DOCKETED	
Docket Number:	19-SPPE-04
Project Title:	SJ2
TN #:	240112
Document Title:	SJC Information Data #2
Description:	N/A
Filer:	Jerry Salamy
Organization:	Jacobs
Submitter Role:	Applicant Consultant
Submission Date:	10/20/2021 1:57:25 PM
Docketed Date:	10/20/2021

From: Salamy, Jerry/SAC
Sent: Thursday, September 30, 2021 11:32 AM
To: Worrall, Lisa@Energy
Cc: Maurath, Garry@Energy; Khoshmashrab, Shahab@Energy
Subject: RE: SJDC- Need updates to Figures 3.7-1 and 3.7-1 to include natural gas lines
Attachments: Fig3_07-2R_Geologic.pdf; Fig3_07-1R_Soil.pdf

Figure 3.7-1R
Soil Types within Project Area
 San José Data Center (SJC02)
 San José, California

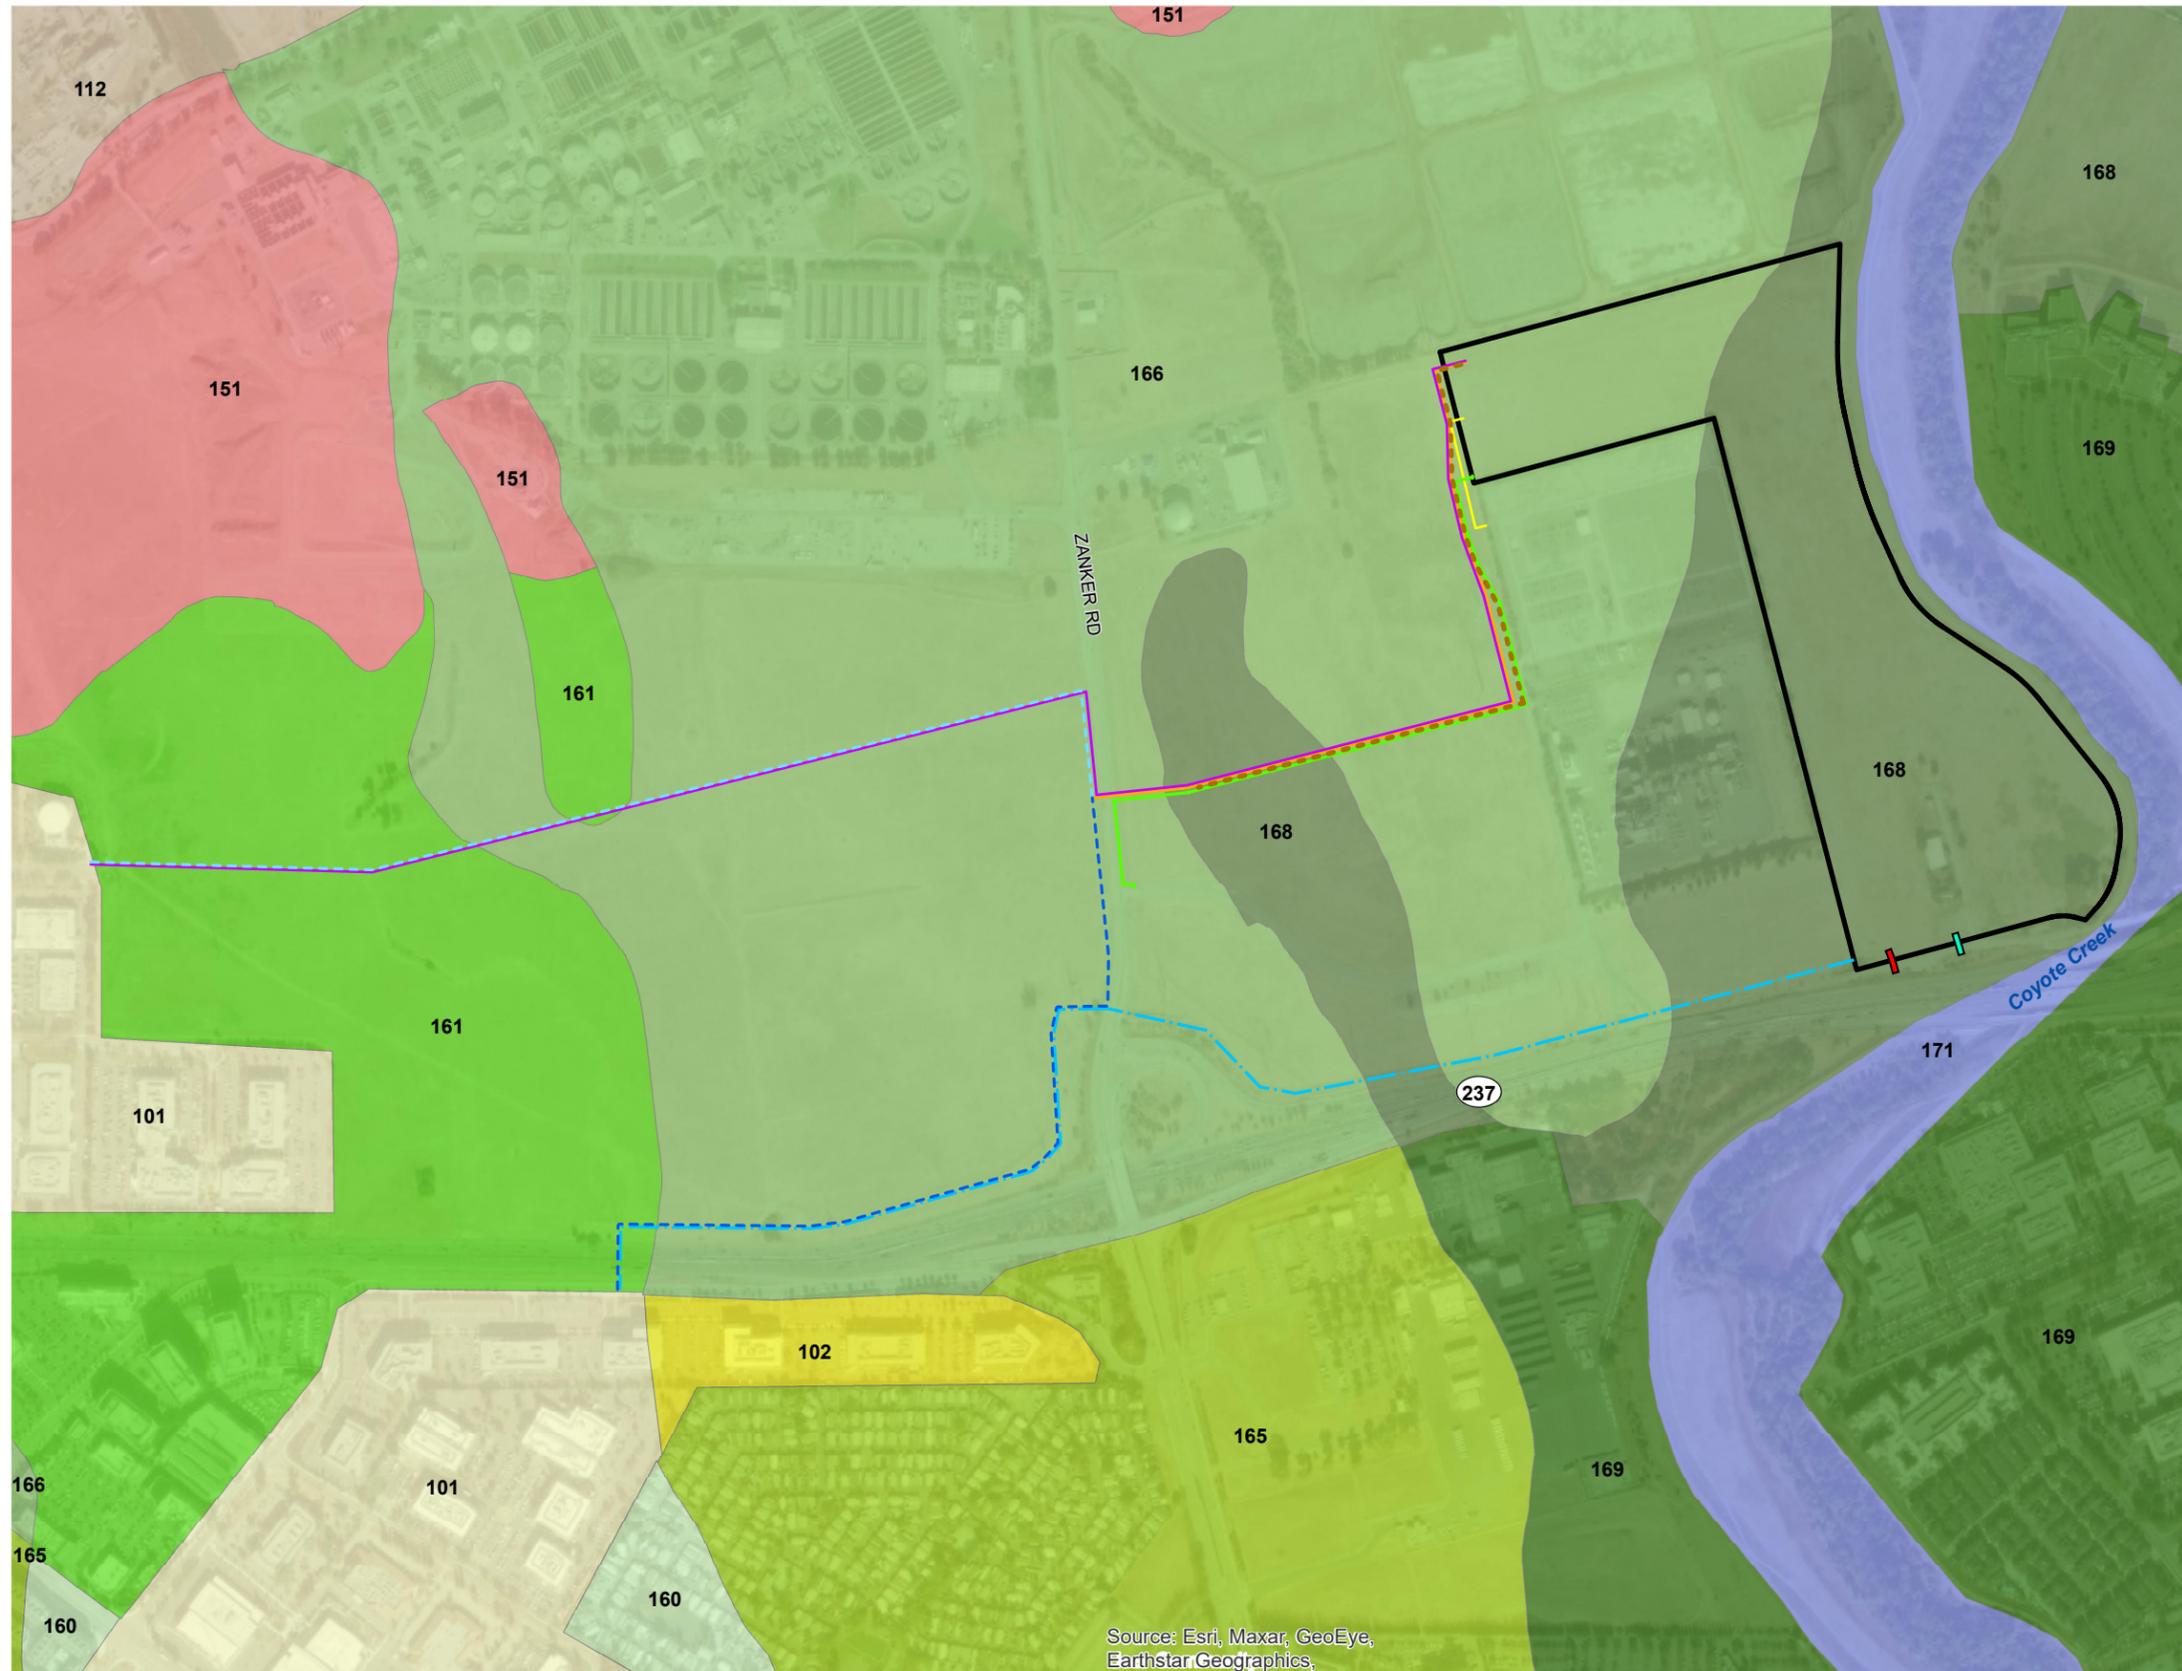
I just discovered that we need two Geology and Soils figures updated to include the natural gas lines. Figures 3.7-1 and 3.7-2 need to be updated.

Attached are the two updated figures.
